Trip Report - Brookville ex-SEPTA PCC Overhaul, May 2016

Update

5/17/2016

Figure 1 – Limit Relay Board

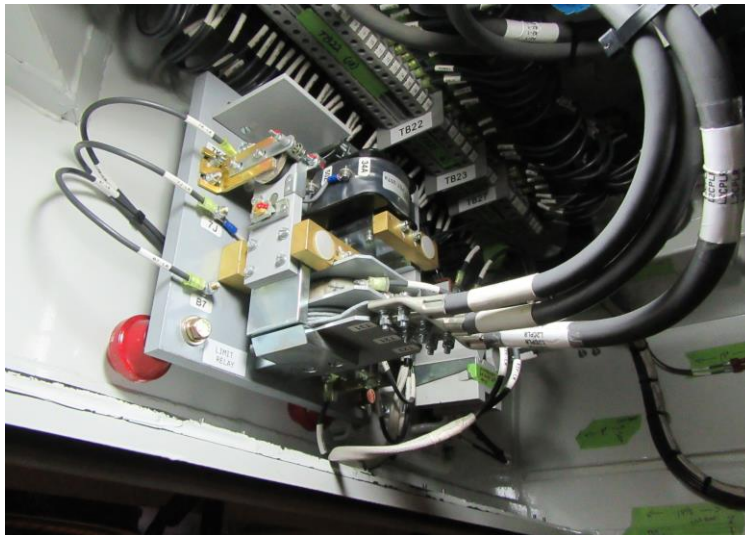
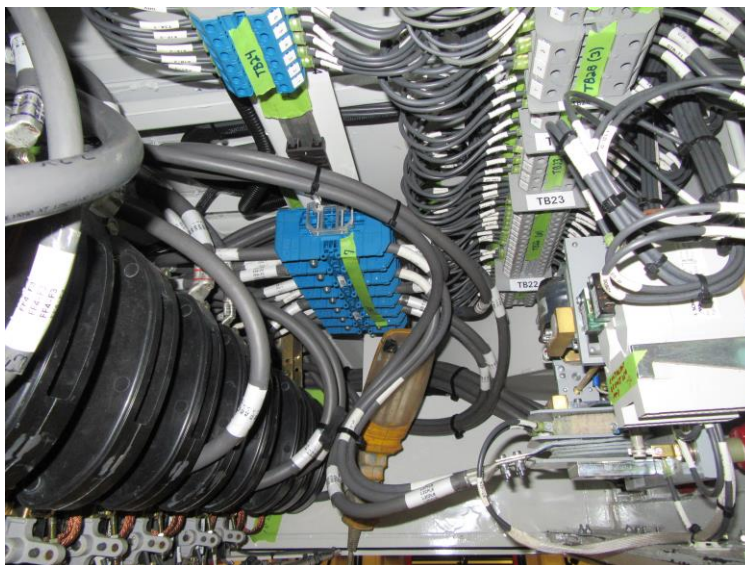
The position of the Limit Relay and connected wiring makes access to the Contactor Panel difficult. Upon discussion with Brookville staff, potential solutions include modified connectors or relocation of the limit relay. Modified connectors would allow the wire runs to come off of the Limit Relay at a 90

degree angle, which limits the intrusion of the wiring into the free space and the Contactor Panel. This connector could either be sourced from Bombardier or a manufacturer by Brookville. Relocation of the Limit Relay would move the potential obstruction toward the end of the enclosure, but clearance issues may still exist.

One suggestion was to connectorize the limit relay for easier maintenance. The Limit Relay Board is often removed and placed on a work bench for service. The current setup consists of a typical bundle of wires and terminal lugs. Replacing the bundle of leads will simplify removal and installation and ensure integrity of connections. This suggestion applies only to the leads to the Limit Relay Board, and not the Series Coil wiring.

Figure 3 - High Voltage Enclosure Terminal Block

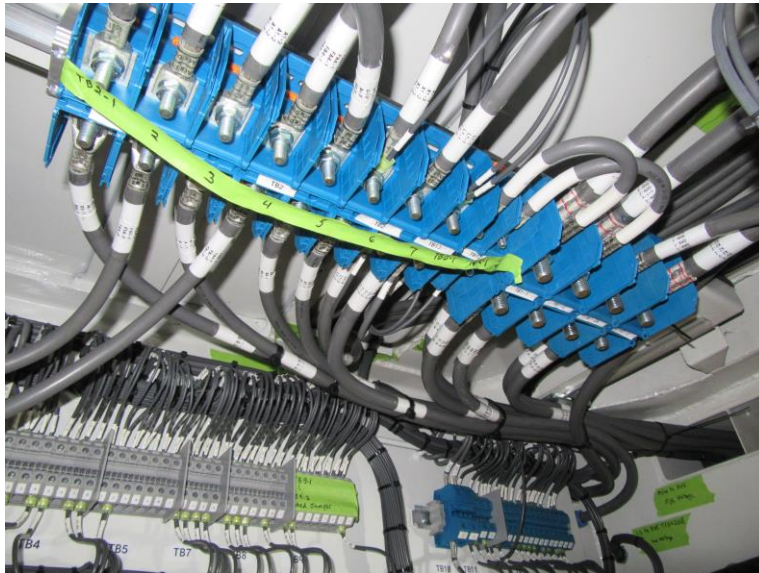
Terminal blocks were installed throughout the rebuilt car, including in the Hi-Voltage Enclosure. Some of the wiring runs were longer than usual, which brought up vibration and chafing concerns. Brookville suggested that the installation of additional tie bars would help alleviate any potential vibration and fitment issues.

Figure 8 – Underdash Electrical Panel

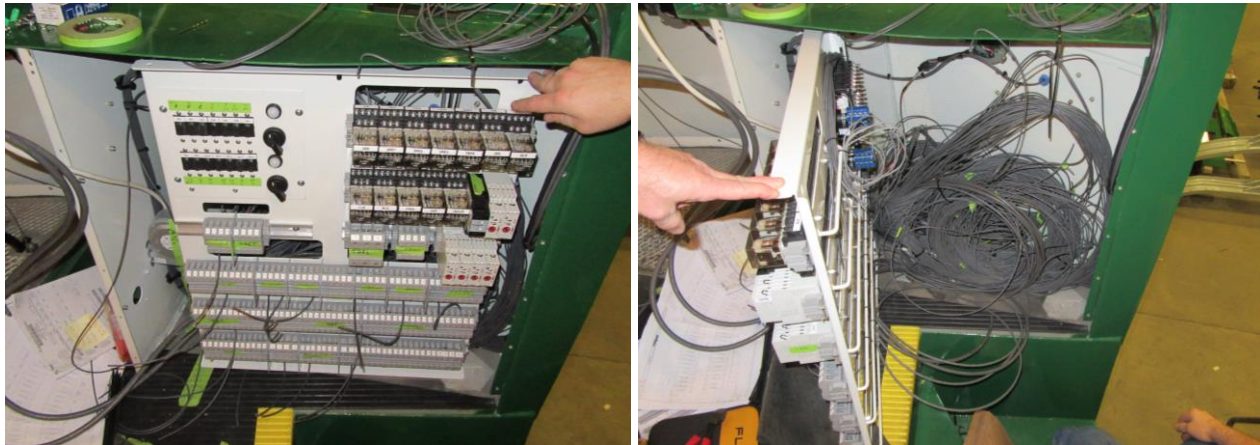
Brookville advised that they planned on installing a swingout front panel for the Underdash Electrical Panel. This feature would ease replacement of any items on the panel, in addition to the components behind the panel such as the wiper motor and heater ducting.

Figure 9 - Underdash Electrical Panel Removal Panel

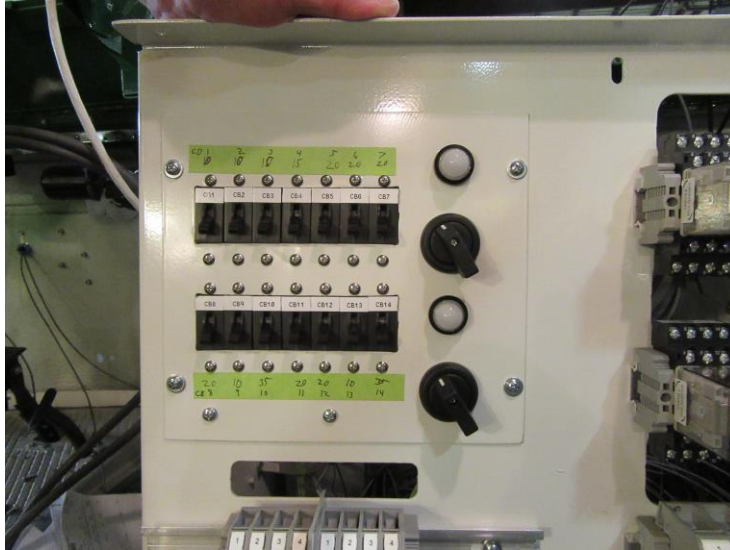
The swingout panel also feature a removable panel for access to circuit breakers, door bypass, and blower bypass switches and indicator lights. This will facilitate maintenance activities, since these items are replaced more often than other parts located on this panel.

Figure 12 – LVPS Wiring

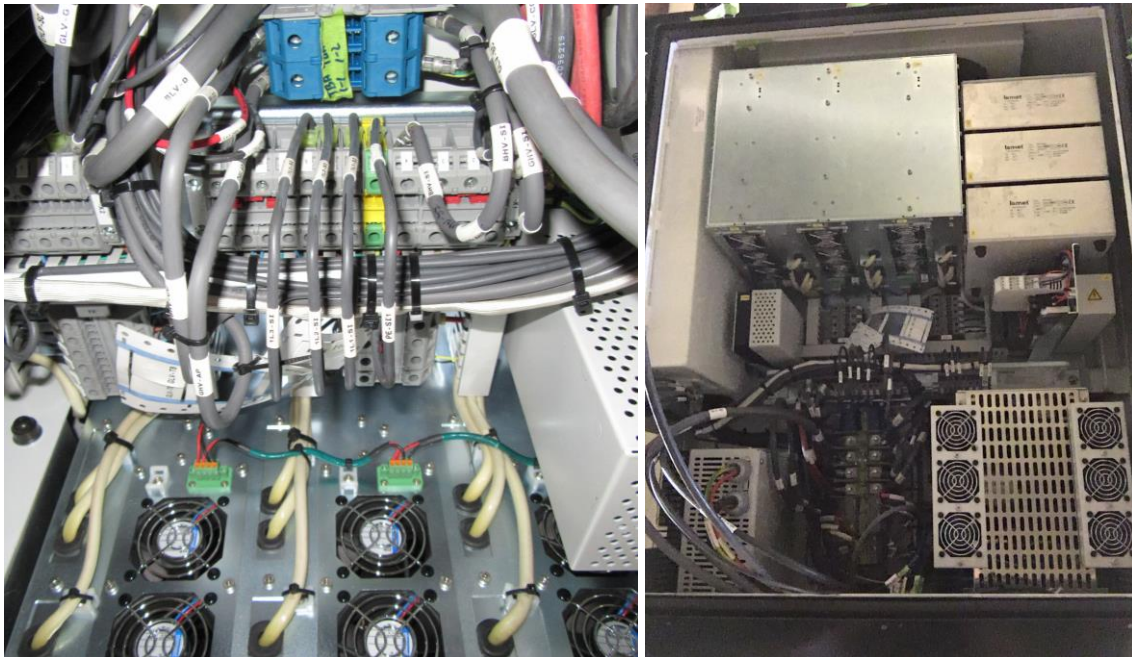
Wiring of the components in this enclosure was completed, with labeling and QA checks being conducted.

Figure 20 – Rear Teardrop Window Modification

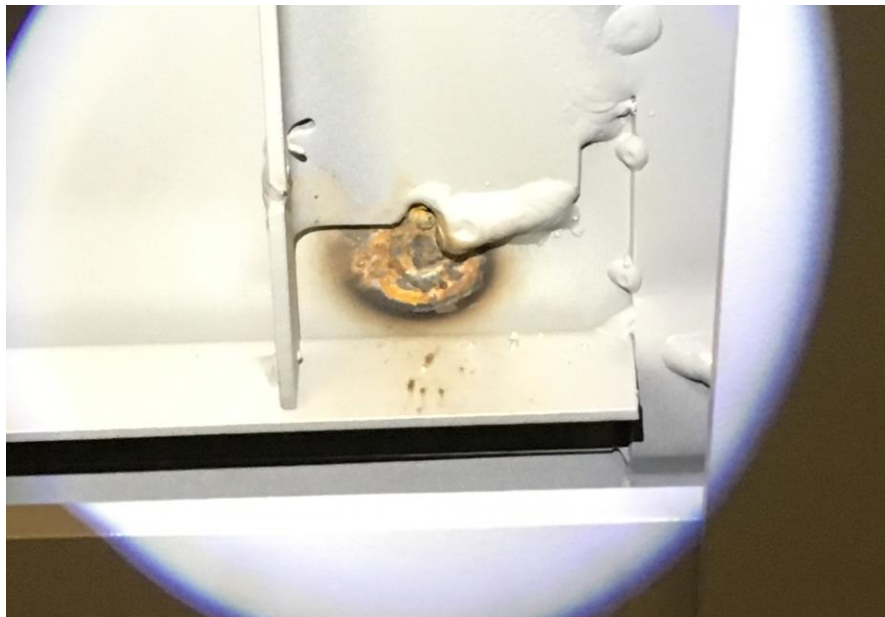
Body repair and all major metal work has been completed on this car. Primer has been applied and the car has been leak tested. Minor leaks were found during this test and have been repaired. Minor metal working is being done based on findings from Car #1. This work includes the addition of bracketing for wiring and modifications to the Rear Teardrop window to ease window installation.

Figure 28 – Rear Door Relay Panel

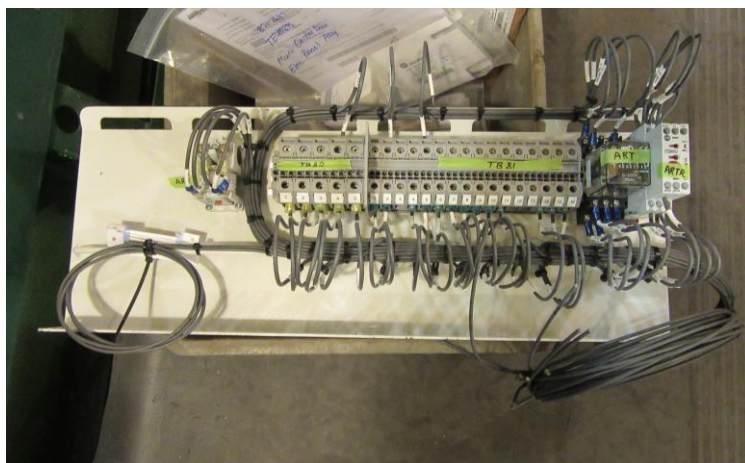
Door System manufacture and final design is ongoing. Manufacture of the door motor header plates and linkages was occurring during our visit. We discussed our experiences with system components during our ongoing Rotary Door drive retrofit, particularly with the door motor cam, linkage, and pivot arms. We also discussed the current configuration of the door chime alarm, in particular the operation when the doors are closed but sensitive edge is activated. It was suggested that the wiring be modified to match the current configuration, which consists of the alarm sounding when the sensitive edge is activated when the door is closed.

Figure 30 – Connectorized Gang Switch Assembly

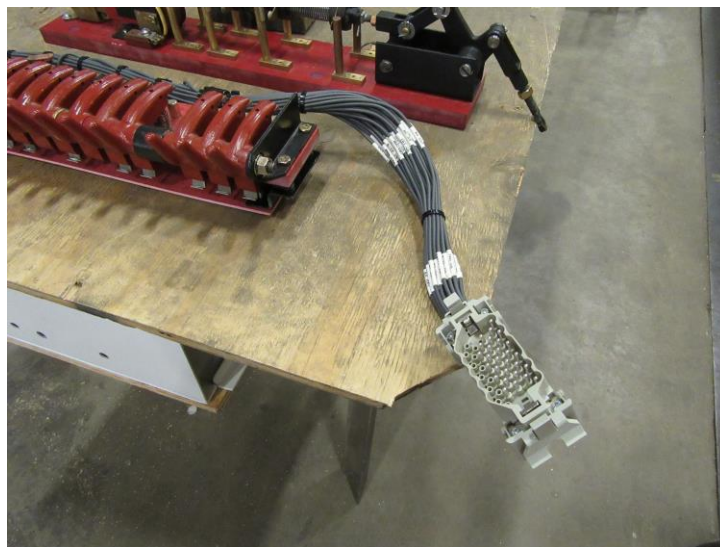
The Gang Switch Assembly has been rebuilt and is ready for installation. The whole unit now features a connectorized wiring harness, which will ease installation, removal, and maintenance. The Sander switch also now utilizes relay control, which will improve reliability due to the removal of high voltage.

Figure 34 – R1 and R2 Resistors

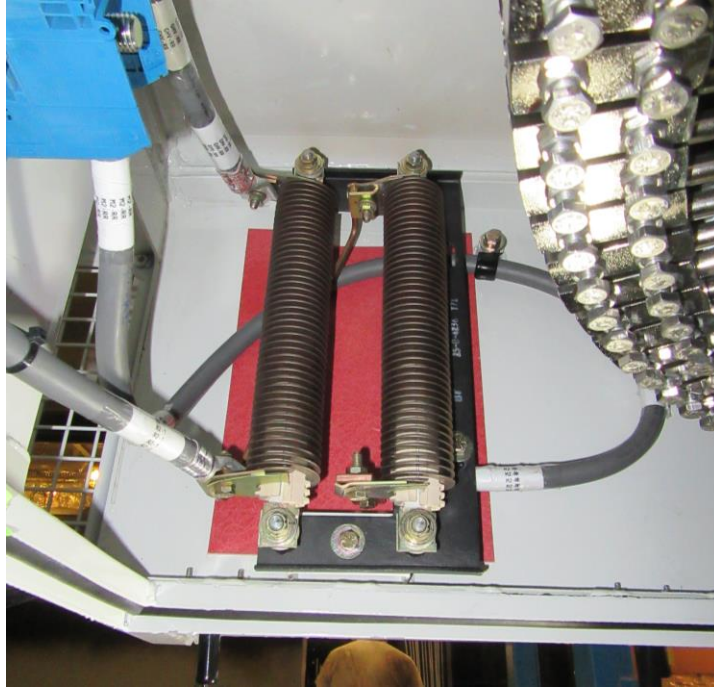
R1 and R2 resistors are now located in the Accelerator Drum Enclosure.

Figure 35 – Traction Motor Fuses

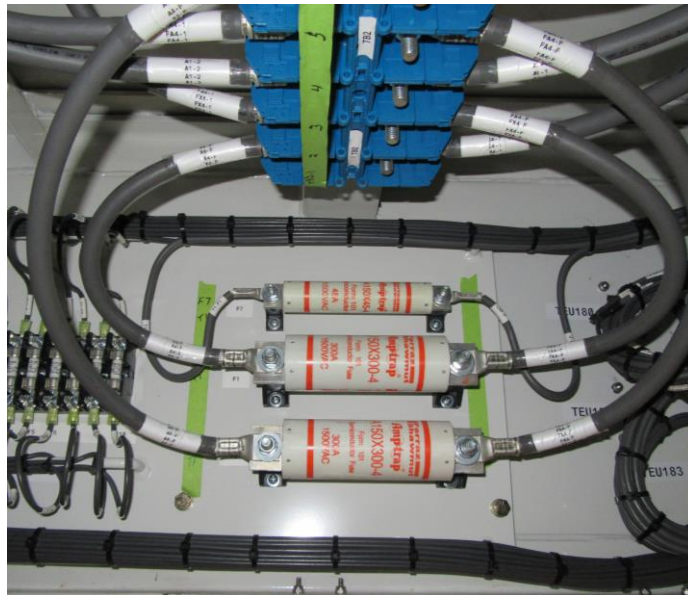
Traction motor fuses are now located in the Hi-Voltage Enclosure.
